Hi-Fi Products Service Bulletin

Model: D15

No. 60

Subject: Does Not Play Gold CDV Disc

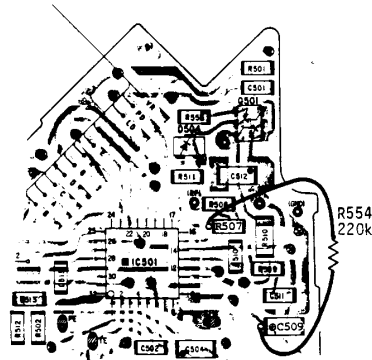
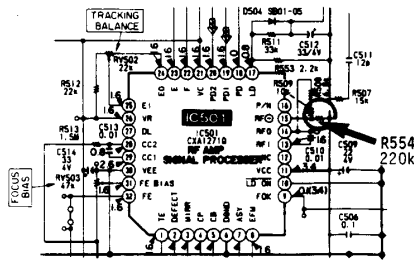
A gold CDV disc may not be played. These discs have a high RF level.

Solution: Add R554 as shown below:

Designation	Description	Part Number
R554	220k Ohm 1/8W	1-247-887-00
